Access Compliance Report

Public Rights-of-Way

(Curb Ramps)

Intersection ID: 44955	Main Street: OAKTON_HUNT_DR	Cross Street: WEAVERS_GLENN_PL	Location: SE
ADA ID: 1A35901F081A	Ramp Type: PerpDiag	Initial Pass/Fail: Fail	Overall Compliance: No
Severity Score: 33.75			
Codes/Mitigation Info/Possible Solution		Field Measurements/Component Compliance

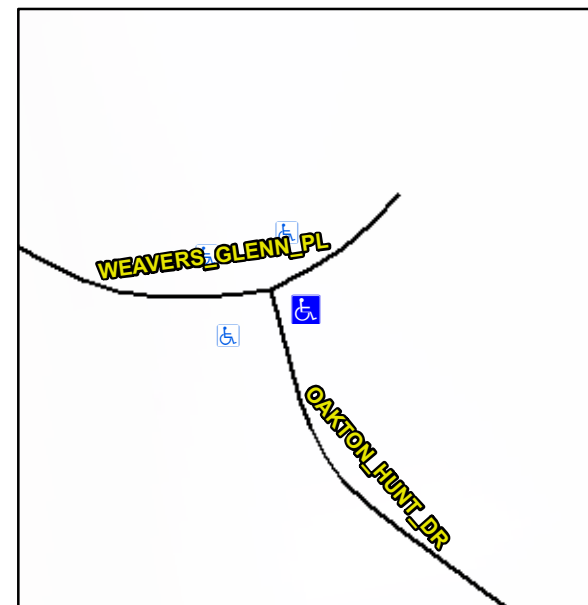
Not Found, R304.5.1, R304.5.3

Compliance	Description	Data	Compliance	Description	Data
N/A	Ramp Length (in)	46.0	Yes	Ramp Slope (%)	6.6
No	Ramp Width (in)	46.0	No	Ramp XSlope (%)	10.1
N/A	Flare Type LT	N/A	N/A	Flare Type RT	N/A
N/A	Flare Slope LT (%)	N/A	N/A	Flare Slope RT (%)	N/A
N/A	Flare Traversable LT?	N/A	N/A	Flare Traversable RT?	N/A
N/A	Landing Length (in)	N/A	N/A	DWS Provided?	N/A
N/A	Landing Width (in)	N/A	N/A	DWS Contrast?	N/A
N/A	Landing Slope (%)	N/A	N/A	DWS Length (in)	N/A
N/A	Landing X Slope (%)	N/A	N/A	DWS Full Width?	N/A
N/A	Landing Curb? (Y/N)	N/A	N/A	DWS Offset (in)	N/A
N/A	Shared Landing?	N/A			
N/A	Gutter Ponding?	N/A	N/A	Gutter Slope (%)	N/A
N/A	Gutter Lip Ht (in)	N/A	N/A	Gutter X Slope (%)	N/A
N/A	Painted X Walk1?	No	N/A	Painted X Walk2?	No
	X Walk 1 Direction	To N		X Walk 2 Direction	To W
N/A	X Walk 1 Width (in)	N/A	N/A	X Walk 2 Width (in)	N/A
	X Walk 1 Slope (%)	2.7		X Walk 2 Slope (%)	0.9
	X Walk 1 X Slope (%)	3.7		X Walk 2 X Slope (%)	7.4

Remove & Replace Curb Ramp With Two New Directional Ramps or Equivalent.
